## SERVICE BULLETIN

No. 2010, Rev. I  
ATA Code 53-10

**SUBJECT: FUSELAGE - PART I, SEAT TRACK MODIFICATION, PART II, INSPECTION AND/OR INSTALLATION OF A WASHER TO THE PILOT'S AND COPILOT'S SEAT FRAME ASSEMBLIES**

Figure 1

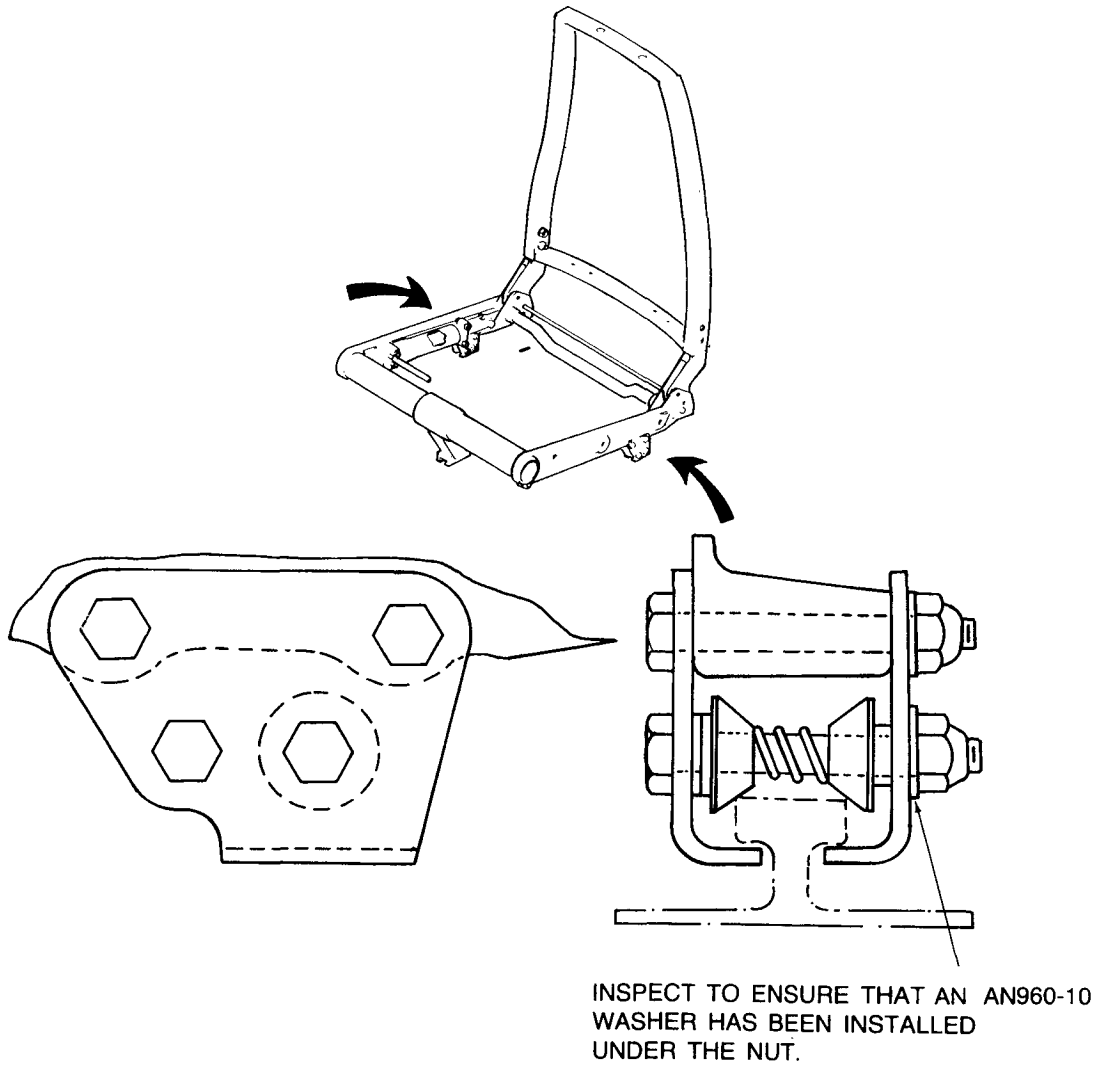
1. Locate the two aft feet on the pilot and copilot seat frame assemblies as shown in Figure 1.
2. Inspect the aft bolt to insure that a P/N AN960-10 washer has been installed under the nut. If a washer has been installed, no further action is necessary.
3. If required, install a P/N AN960-10 washer (obtain locally) under the nut, on the lower aft bolt as shown in Figure 1. This applies to both the left and right hand sides of the pilot and copilot seat frame assemblies.
